**CAMDEN FAMILY HEALTH, INC.
NICHOLAS COUNTY, WEST VIRGINIA
CAMDEN-ON-GAULEY RICHWOOD CLINIC**

ADDENDUM #3

June 30, 2022

THRASHER PROJECT #060-10260

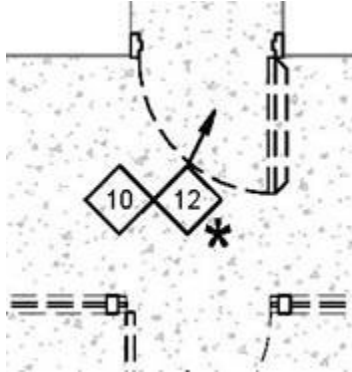
On the demo pages there are several keynotes like pictured above. Please clarify if this means both notes attached are a part of alternate #1 or if note 12, for example, is a part of alternate #1.

Asterisk identifies that Sheet Keynote #12 is a part of Alternate #1. Sheet Keynote #10 is not a part of Alternate #1. Other locations with multiple sheet keynotes will follow the same rule. An asterisk must be placed next to each sheet keynote.

1 FIRST FLOOR PLAN - DEMOLITION
 A1.02 1/4" = 1'-0"

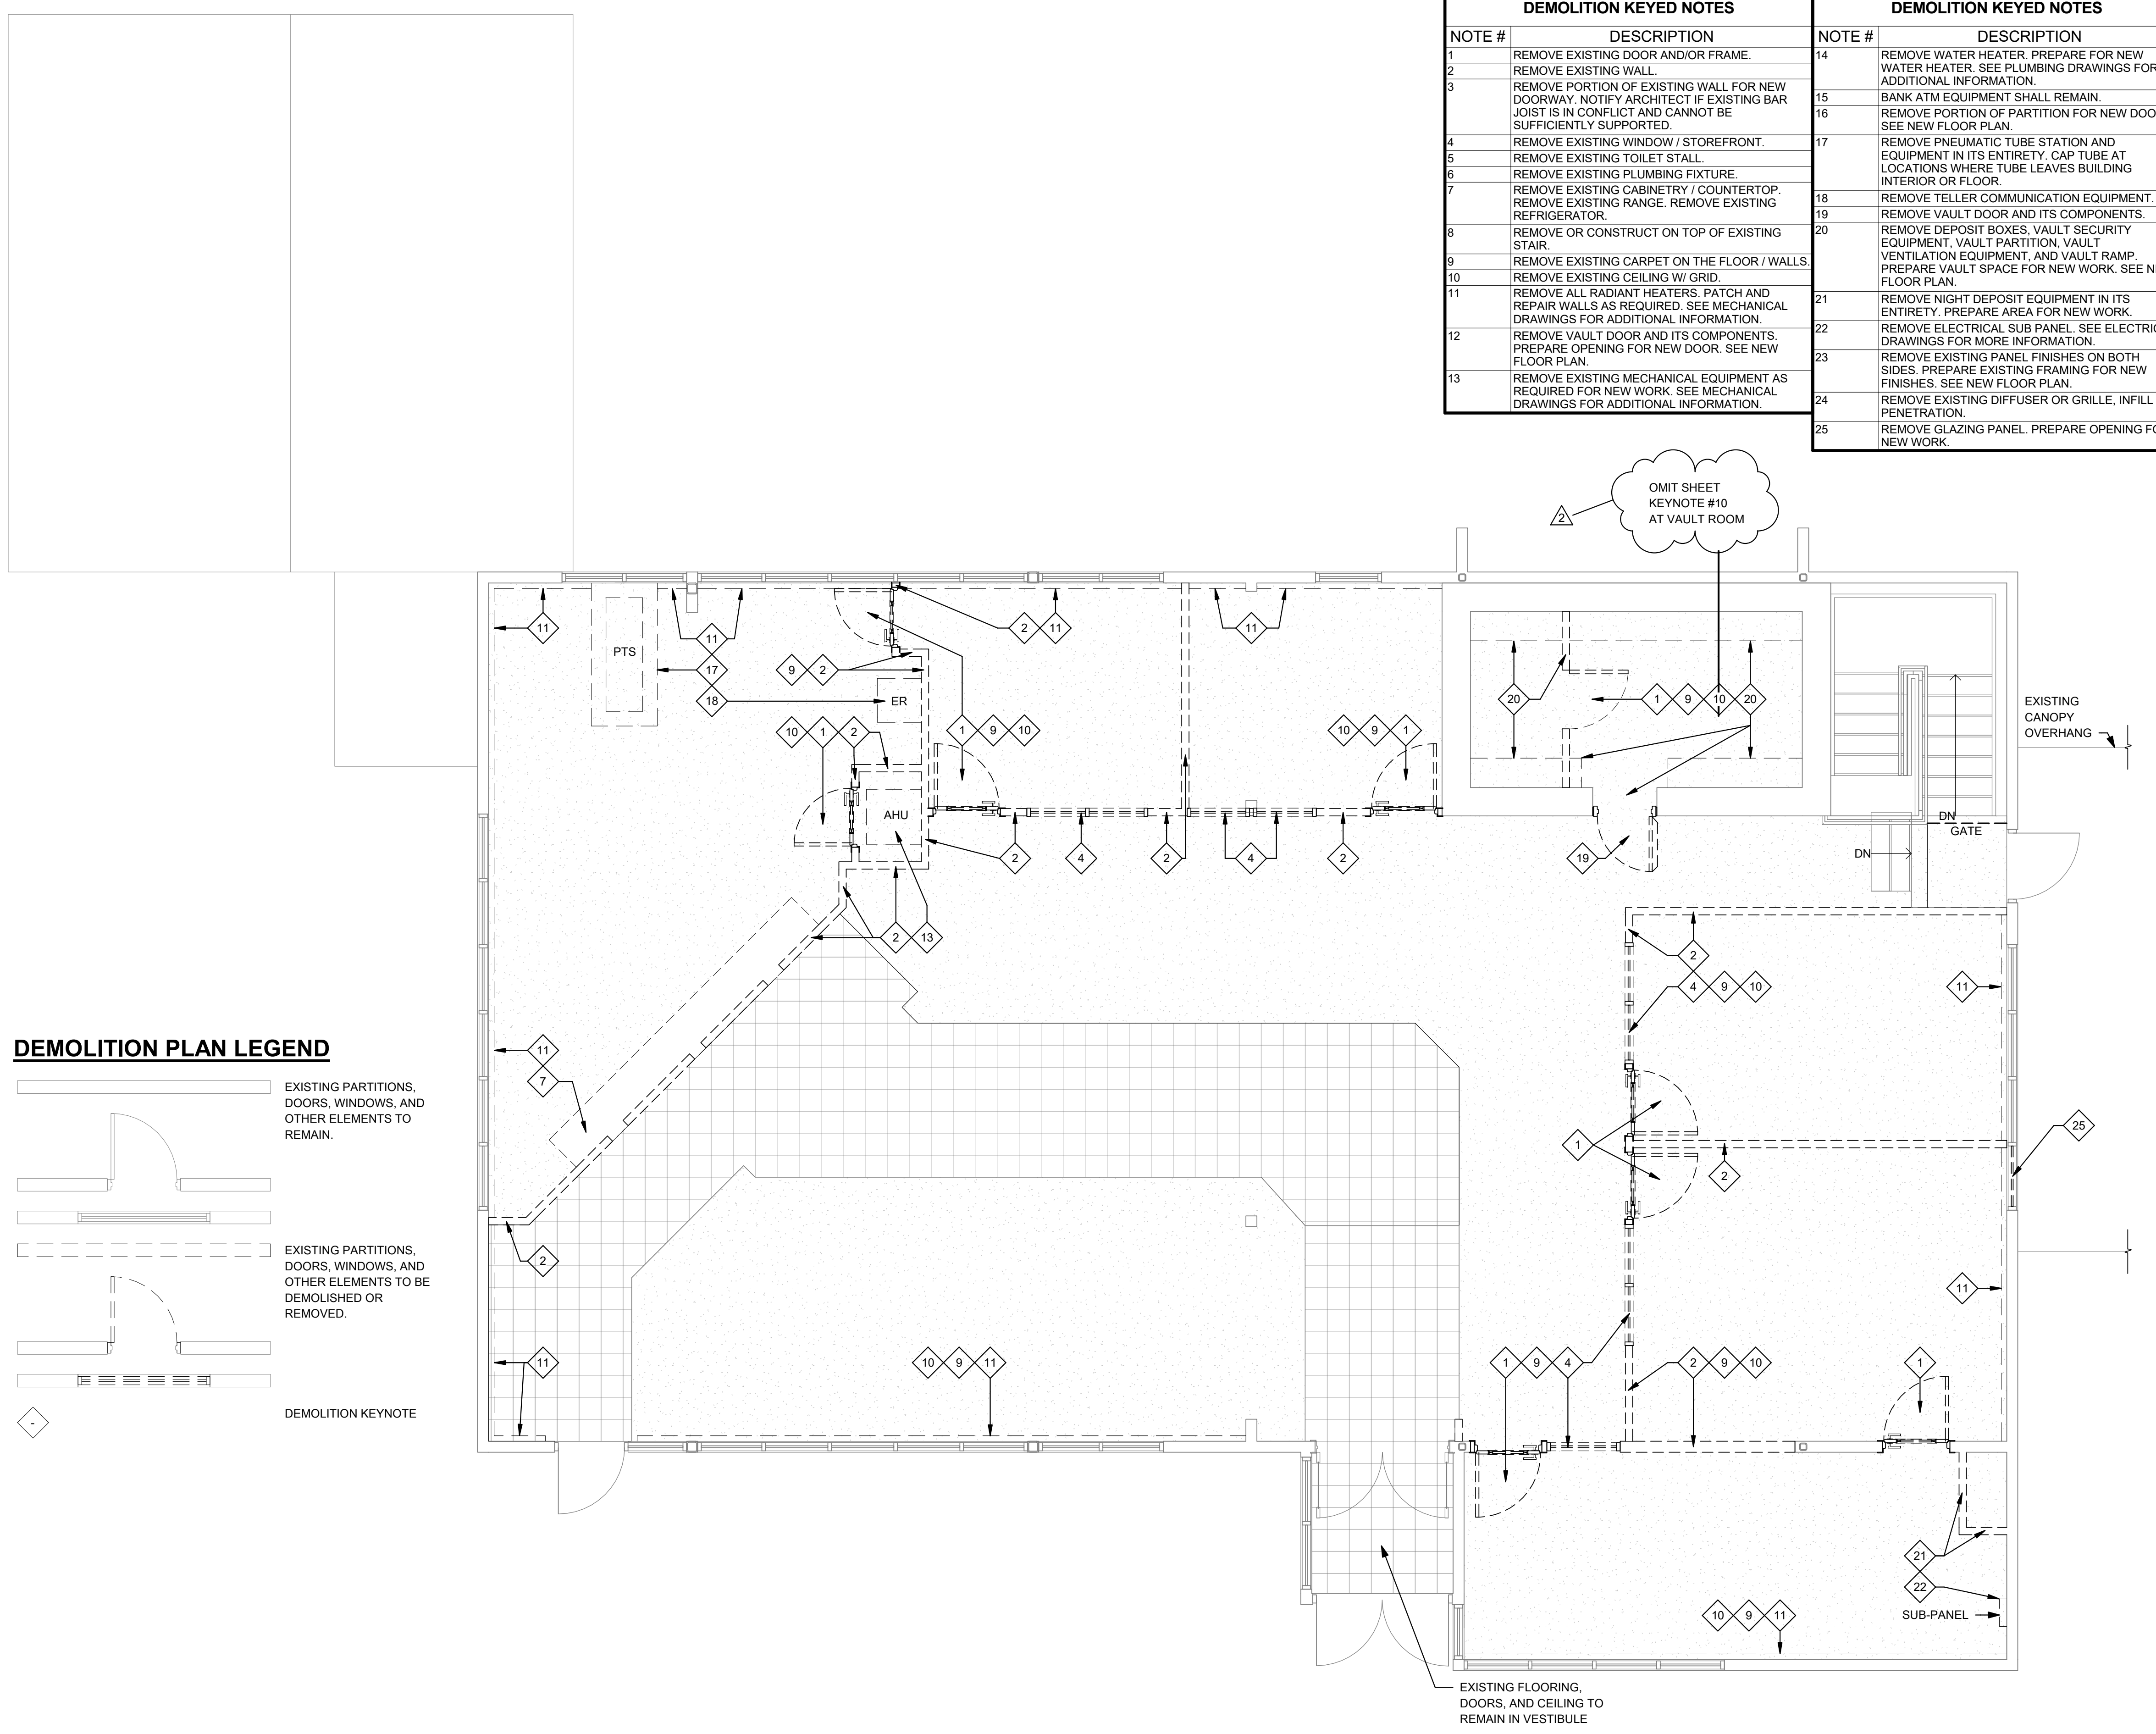
15. Please see question below: On Page #A1.02 “First Floor Demo”, the vault room is tagged with Note 10 indicating to remove the existing ceiling, but on Page #A1.06 “First Floor RCP”, it shows only to remove a portion of the ceiling. Please clarify if we are to remove the entire ceiling or just a certain amount.

On Sheet A1.02, Sheet Keynote #10 shall be omitted in the existing vault room. To clarify, removing a portion of the existing ceiling is related to providing an opening for the new supply air duct.

1 GROUND FLOOR PLAN - NEW
1/4" = 1'-0"

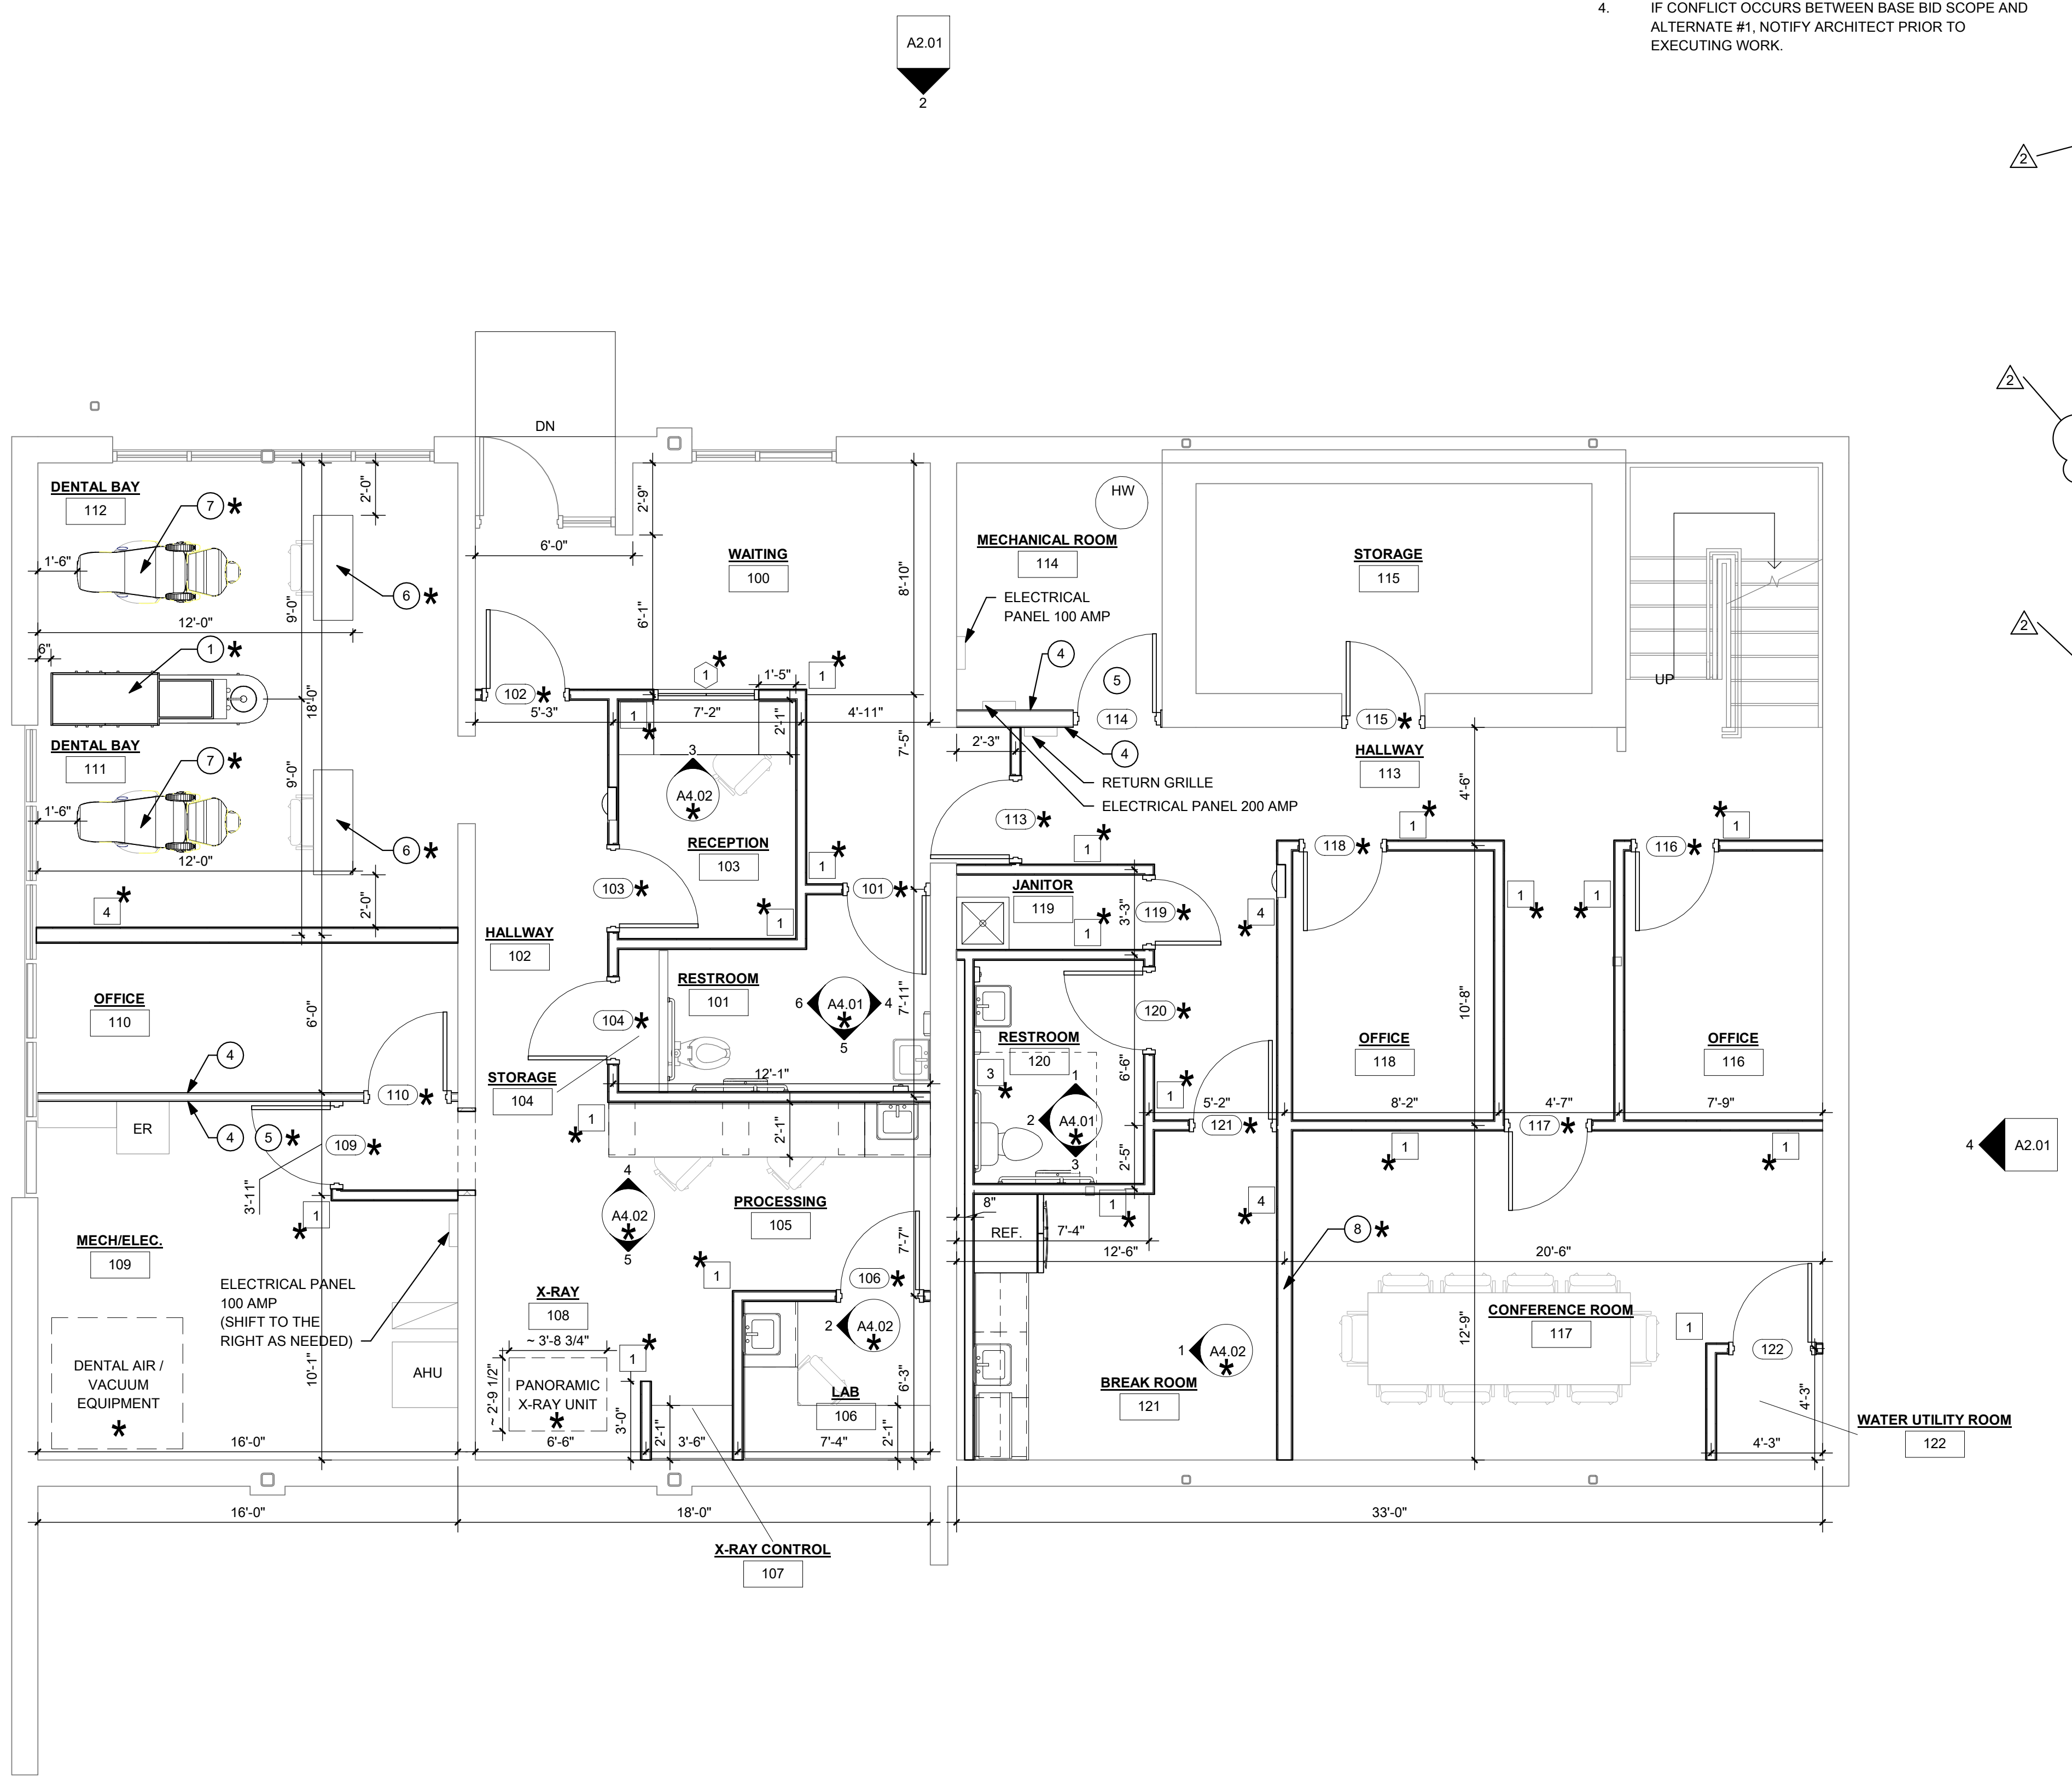
8. On Page #A1.03 “Ground Floor Plan – New”, are the Dental Air/Vacuum Equipment & Panoramic X-Ray Unit Owner supplied/Contractor Installed? If not, could the basis of design be given?

9. Drawing A1.03 Note 1,6 and 7 Dental equipment “Owner to order and contractor to receive and install”. We have never installed the dental equipment that was always done by supplier. Please confirm that we are to install?

The Dental Air/Vacuum Equipment & Panoramic X-Ray Unit shall be owner supplied and owner installed. The final plumbing and electrical hookups shall be performed by the contractor.
